H17	BT00.00-X-1000Z	Technical modifications	30.6.99
------------	-----------------	--------------------------------	----------------

Production breakpoint/Modifications/New features

P09.41-2002-01

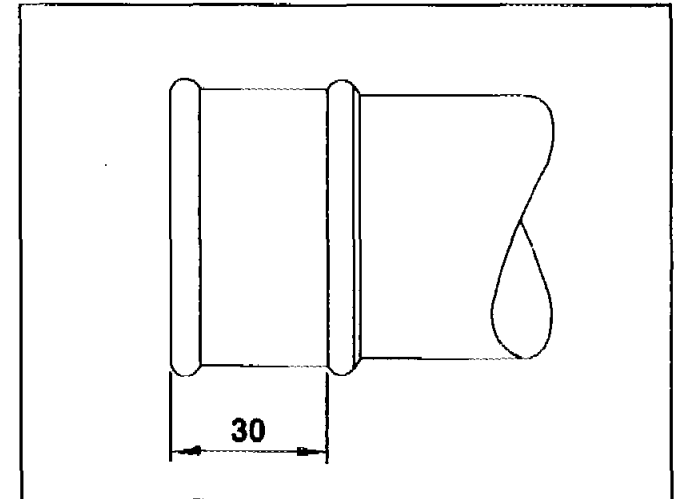
The fit-on length has been increased from 22 mm to 30 mm.

P09.41-2001-01

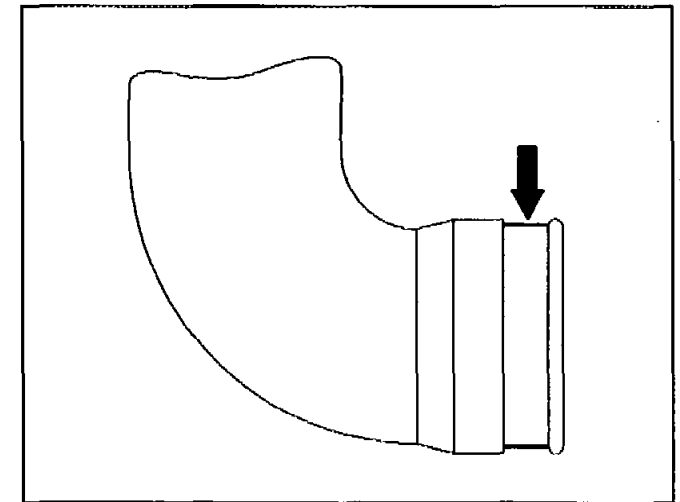
The charge air hoses have an 1.5 mm deep groove (arrow) for the hose clips.

P09.41-2003-01

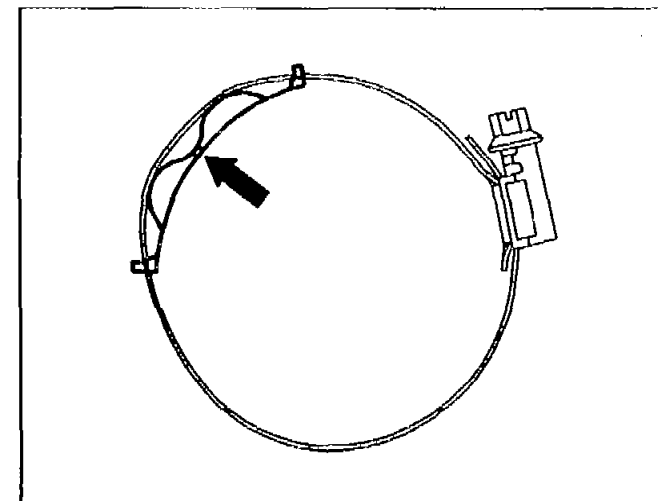
The hose clips have a spring segment (arrow).

Dimension 50 - 70 mm part no. 006 997 26 90

Dimension 60 - 80 mm part no. 006 997 27 90

Dimension 70 - 90 mm part no. 006 997 60 90

017	BT14.10-P-9404-01G	Exhaust manifold in a double-wall design		
-----	--------------------	--	--	--

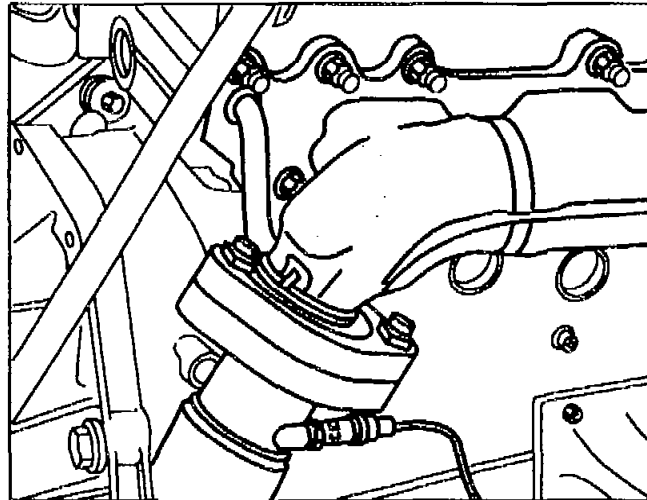
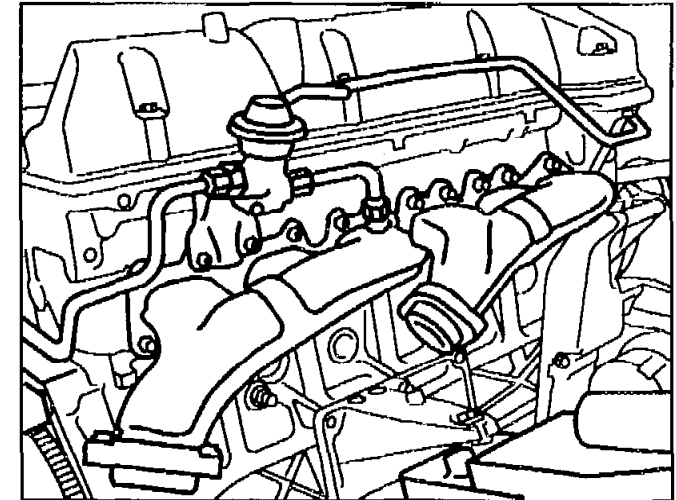
In order to reach the operating temperature more quickly, an exhaust manifold in a double-wall design (insulated by an air gap) is installed.

Modified exhaust nuts are to be used for installation
